Progress Report
Fourth Quarter 2008 – October 1st to December 31st
Midwest Roadside Safety Facility
Midwest State's Regional Pooled Fund Program
December 15, 2008

Pooled Fund Consulting Summary

Figure 11. TCB Tie-Down through 3" Asphalt Overlay.

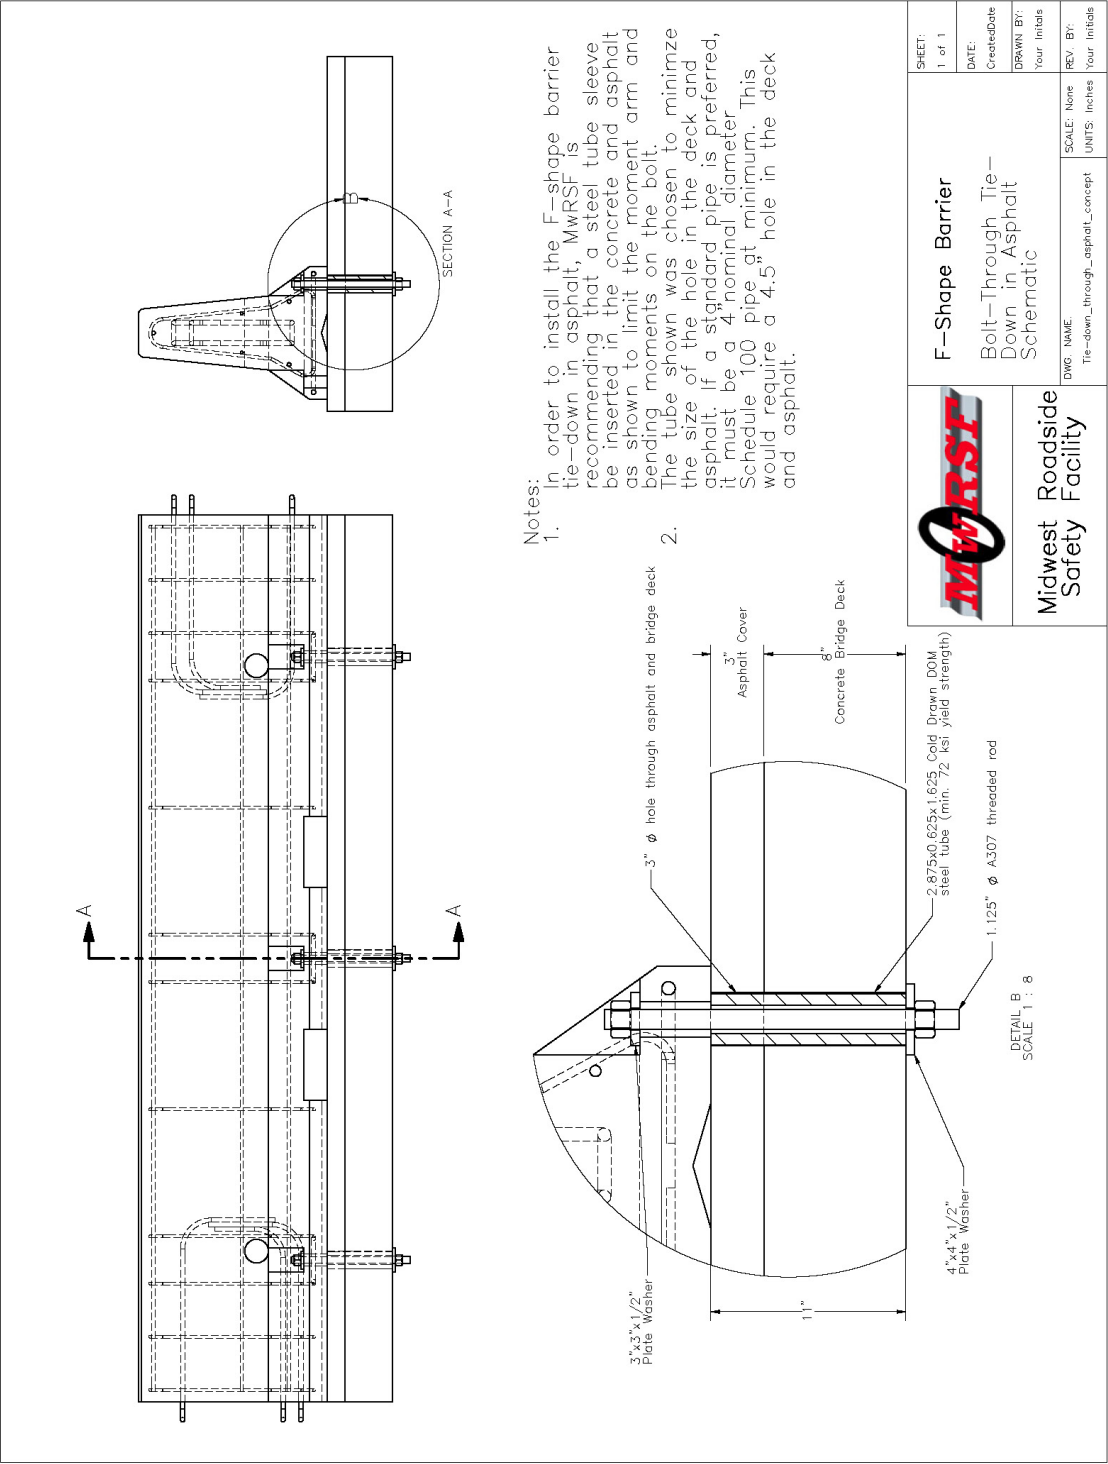
Currently, our detail (see attached) does not allow this. Why does the barrier need to rest on concrete? If there is an asphalt overlay on the bridge deck, is there some other modification to the design that we should do?
